Public Hearing

CASE SUMMARY SHEET

CASE NUMBER: V26-06-17
DATE RECEIVED: April 30, 2026
DATE OF MEETING: June 9, 2026 and June 23, 2026

REQUEST: V26-06-17 – Robert and Karen Bordes request a variance to CLURO Section 8.1.5. Supplemental Regulation of Accessory Buildings and Structures and Section 5.2.3.3. Fill Sub-Area B, Old Town of Mandeville, Square 43B Lot C, O/R - Office/Residential District, 724 Carroll

SITE PLAN

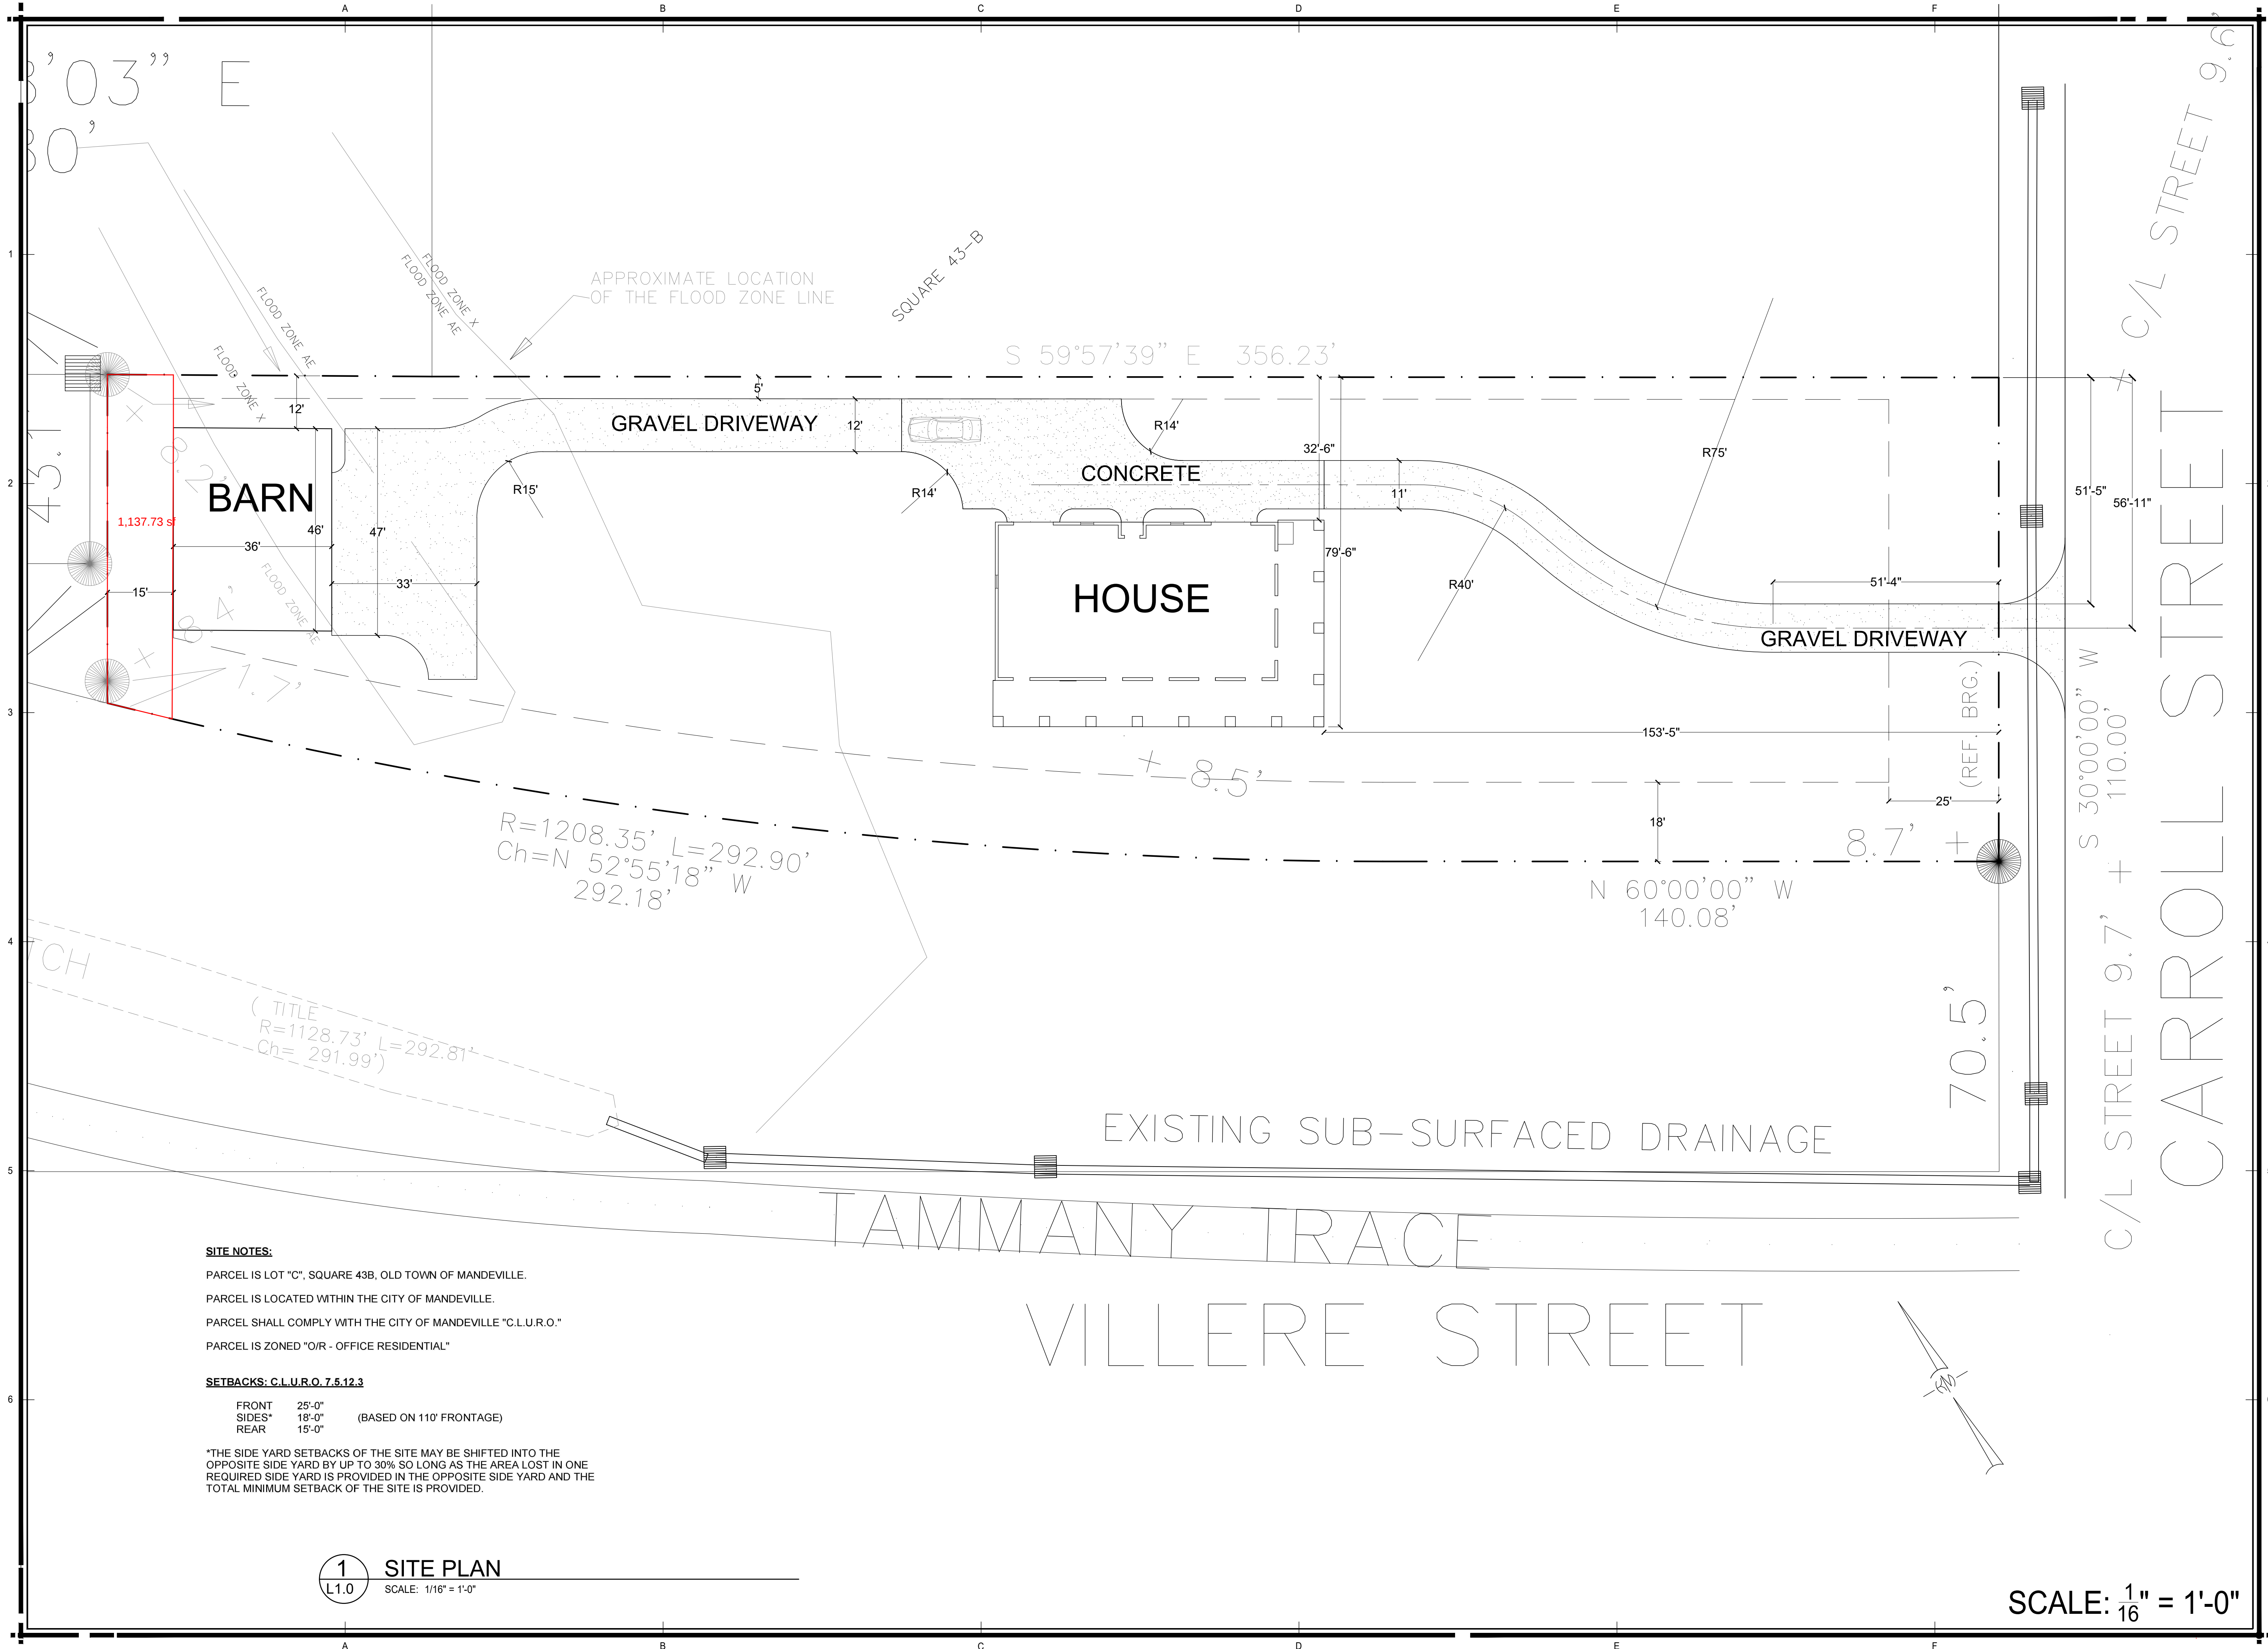
We do not have a drainage plan produced for this building, but I can use information provided from the documents submitted for the permit on the primary structure. The applicant is proposing elevating the slab for the garage to Elevation 11.0 to comply with FEMA regulations. However, Section 5.2.3.3 Fill Sub-Area B 3 Slabs for Non-Habitable Areas only allow “6” inches (0.5’) of height above grade for any other slab”. The average existing elevations within the area of the proposed garage is (8.65’) . Fill Sub Area B would only allow the top of slab to be elevated to (9.15’). The variance request is to elevate the slab to elevation (11.0) a difference of (1.85’) . Additionally, 5.2.3.3 Fill Sub-Area B 1.f. allows for elevating the driveway 6” except within 16’ of the slab to ramp up onto the bottom slab. An additional variance maybe required for the driveway depending on the desired slope to access to building. According to the drainage plan submitted for the primary structure a 1% slope is shown for the driveway approaching the building. If the owner is looking to achieve the same slope the driveway surfacing near the garage would need to be elevated to (10.7’) which would result in fill height for the drive (1.1’) above the allowable (0.5’).

AS-BUILT DRAINAGE OF
A PORTION OF GROUND SITUATED IN SQUARE 10
TOWN OF MANDEVILLE * CITY OF MANDEVILLE
ST. TAMMANY PARISH, LOUISIANA

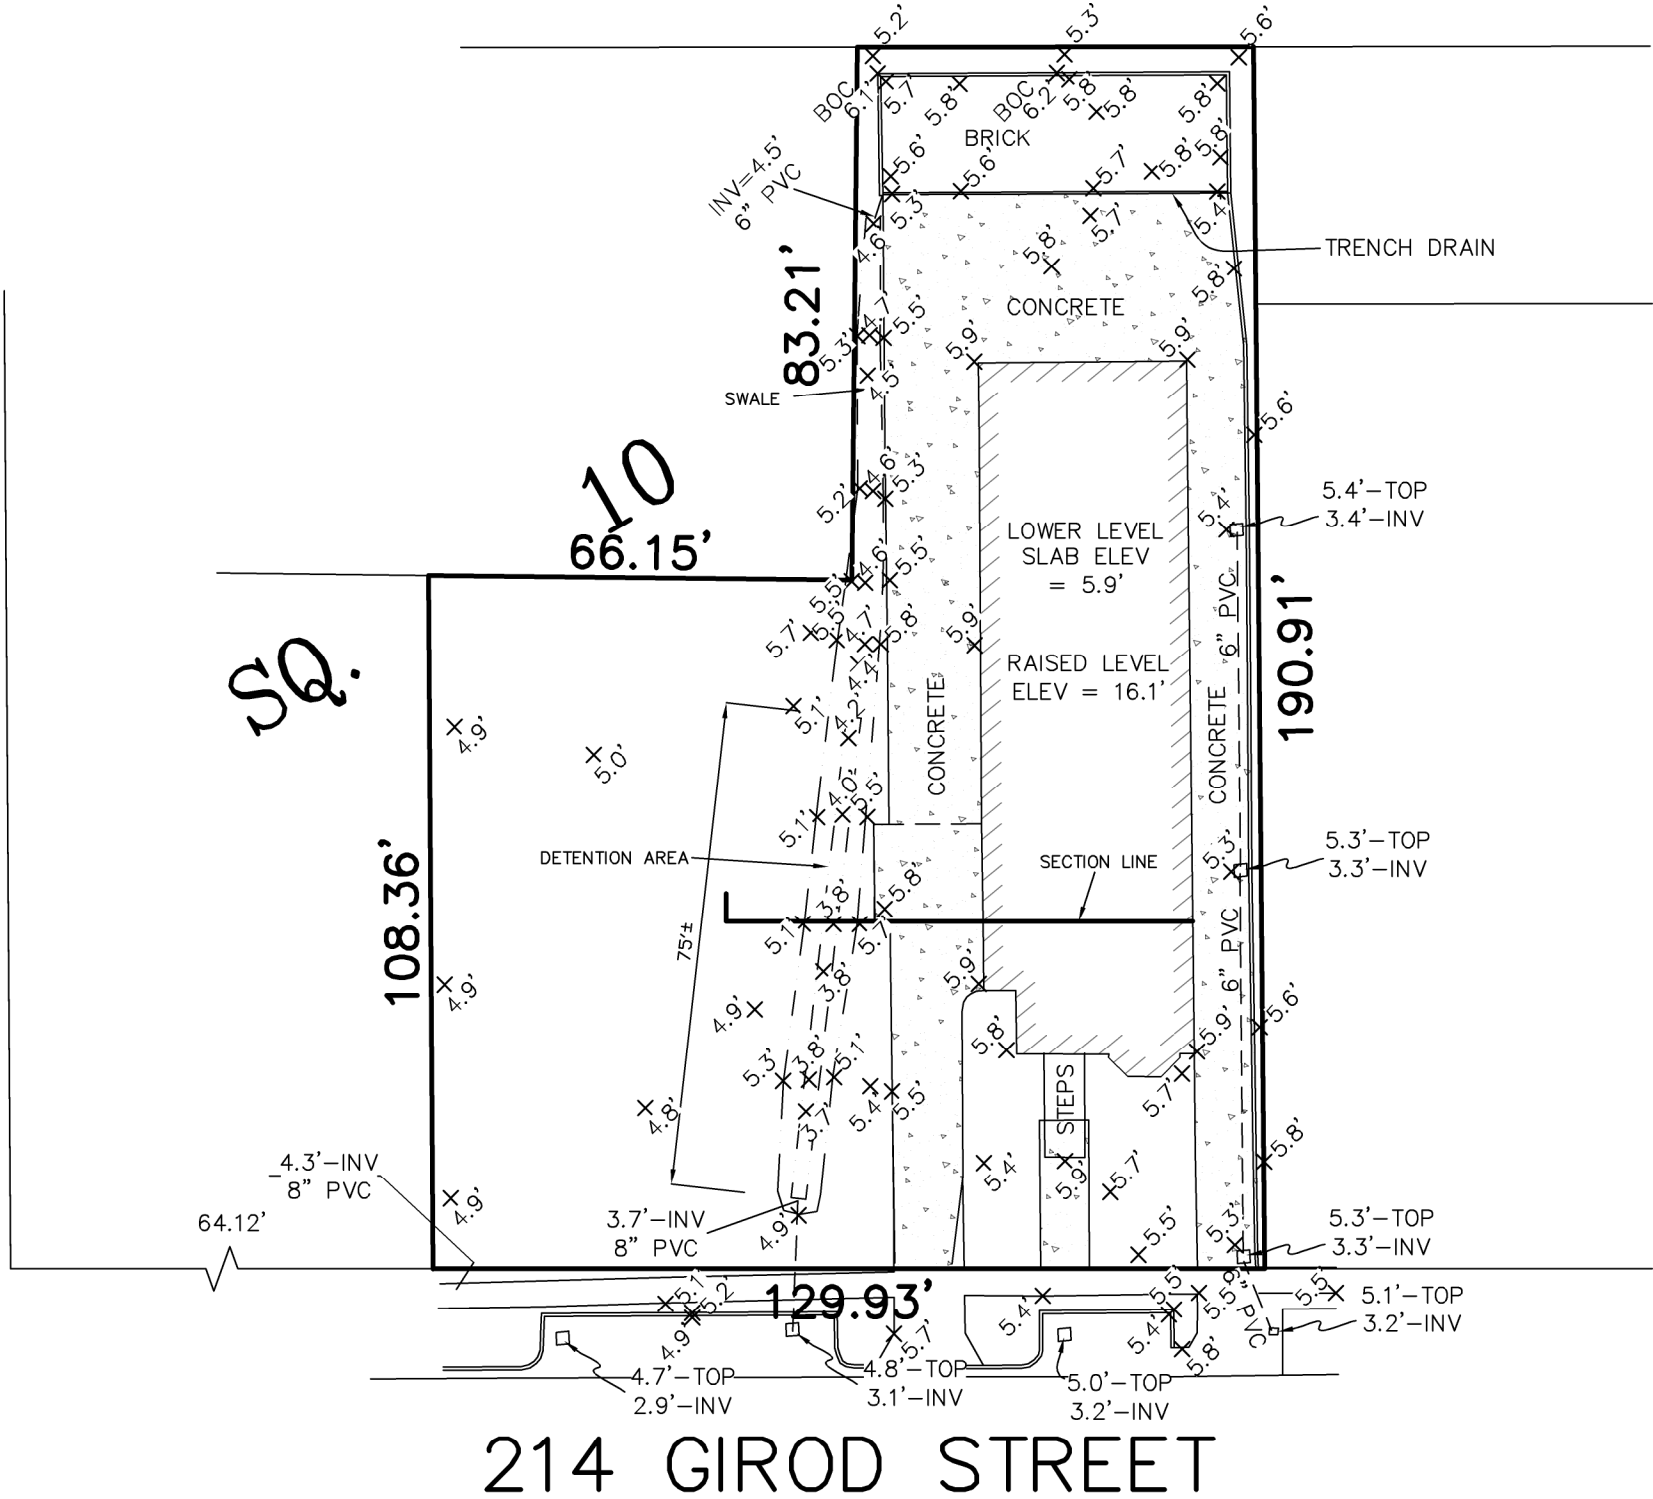
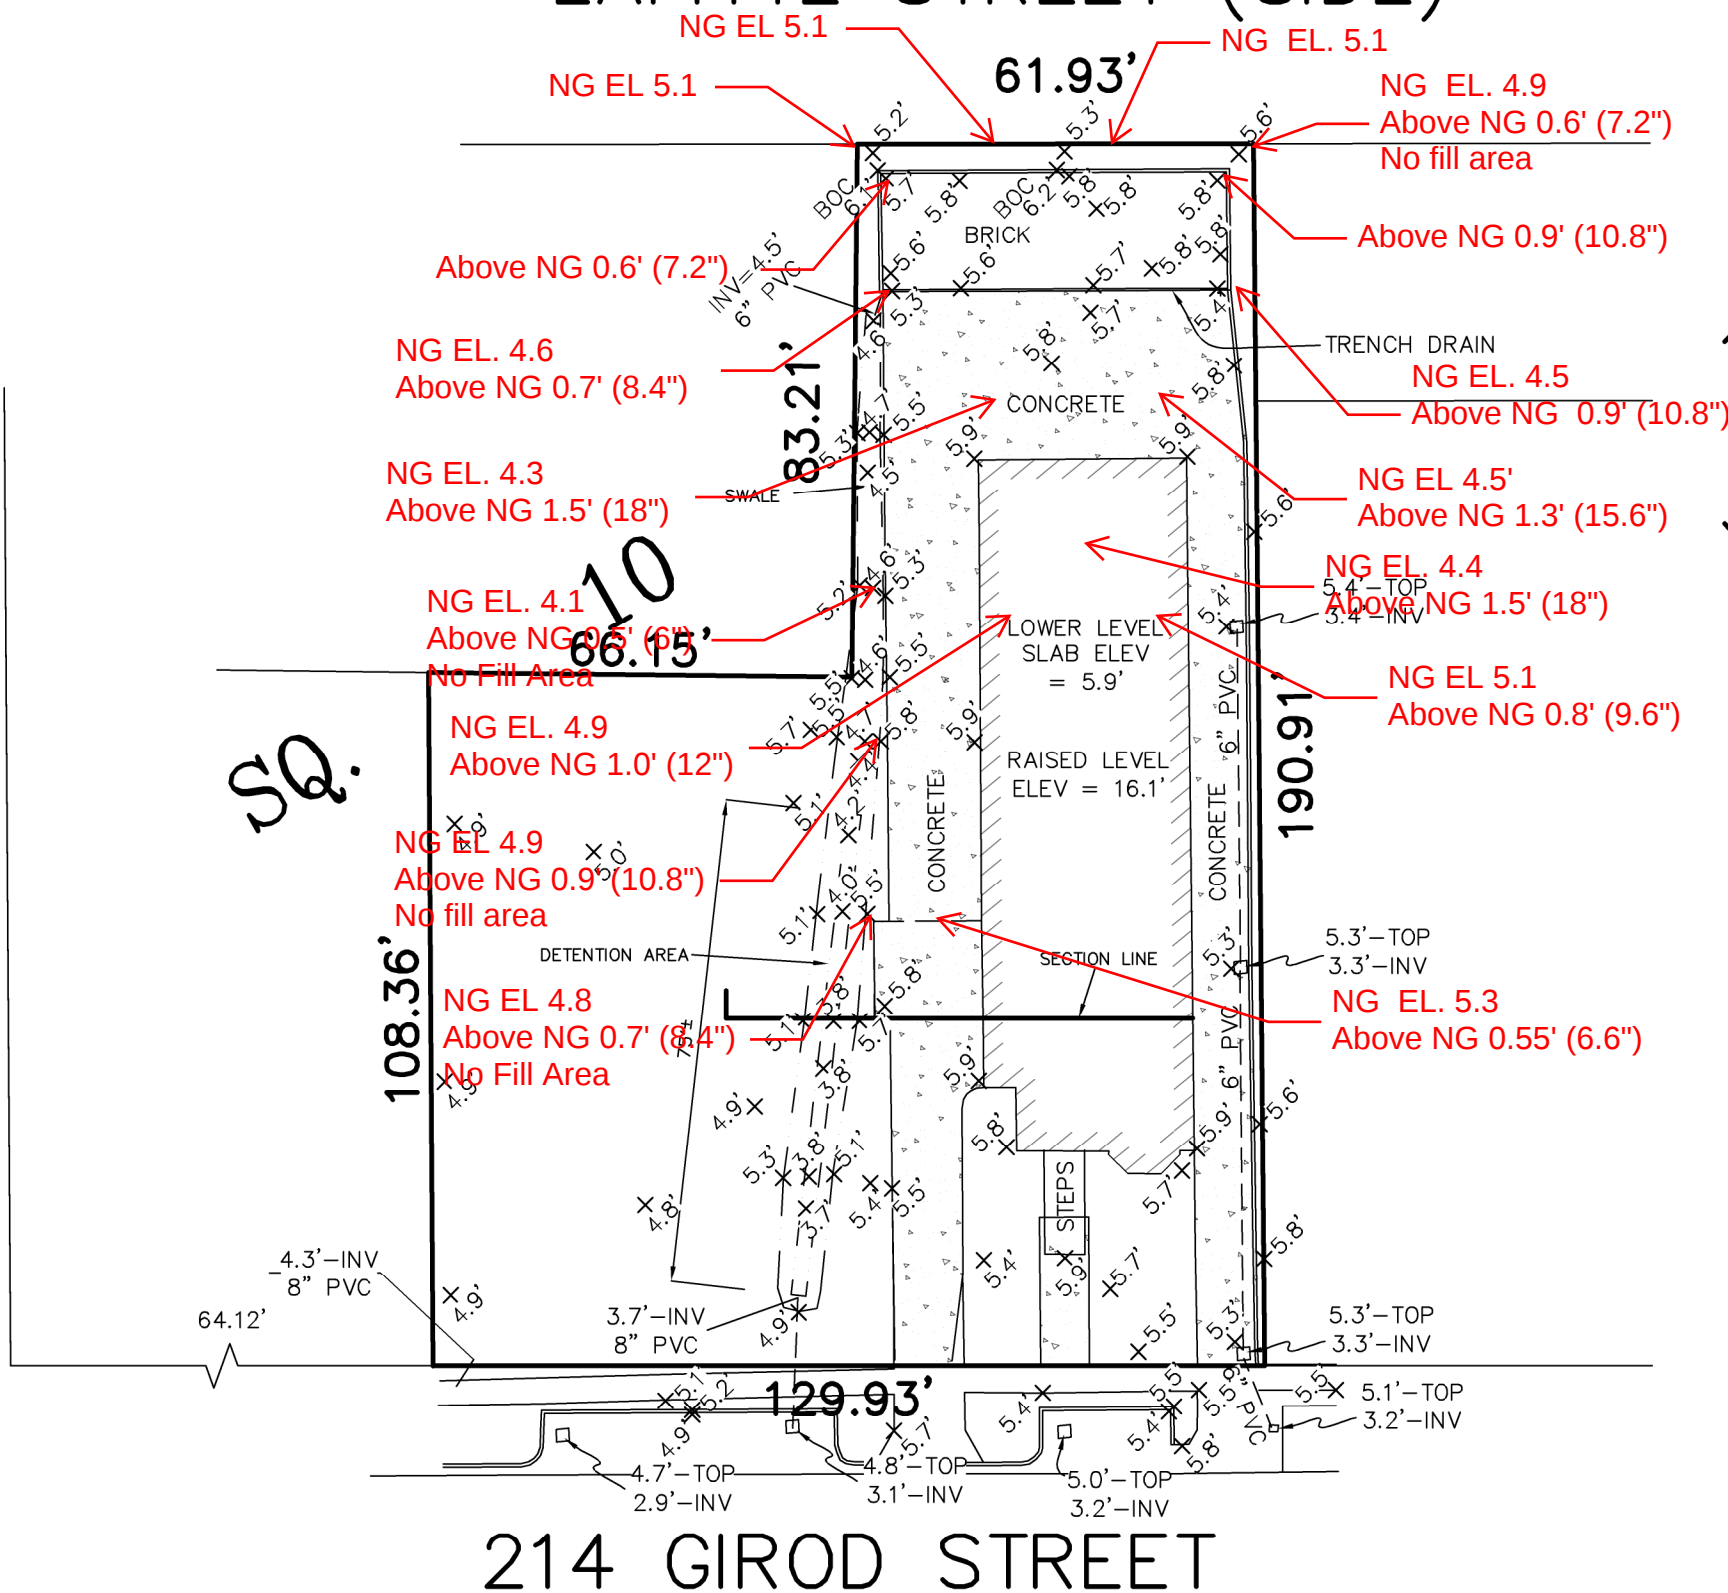
The City Engineer reviewed the submitted documents and had the following comments: *“This project is in both the DO Overlay and Fill area A. It appears they used the grading/drainage plan in the original plan set, that was not approved, was used to set the elevation of the slab under the structure. The first approved drainage/grading plan was prepared by JV Burkes and dated 1/30/2024. See attached. The permittee then requested to change the gravel driveways to be changed to concrete driveways and the gravel parking to permeable pavers, the approved plan was prepared by Kyle & Associates and dated 10/29/2025. Due to not using the plans to set the elevation has resulted in fill up to 18” deep in the rear of the structure”.*

The City Engineer also prepared a figure using the drainage as-built, and noted both the natural grade (NG) of the site prior to construction and the fill above the natural grade in both feet and inches (shown in the parenthesis).

Attached is a figure that I made using the Drainage as-built, I noted the natural grade (NG) of the site prior to construction and the fill above the NG in both feet and (inches). I thought was the easiest way to show.

It appears they used the grading/drainage plan in the original plan set, that was not approved, was used to set the elevation of the slab under the structure. The first approved drainage/grading plan was prepared by JV Burkes and dated 1/30/2024. See attached. The permittee then requested to change the gravel driveways to be changed to concrete driveways and the gravel parking to permeable pavers, the approved plan was prepared by Kyle & Associates and dated 10/29/2025. Due to not using the plans to set the elevation has resulted in fill up to 18" deep in the rear of the structure.
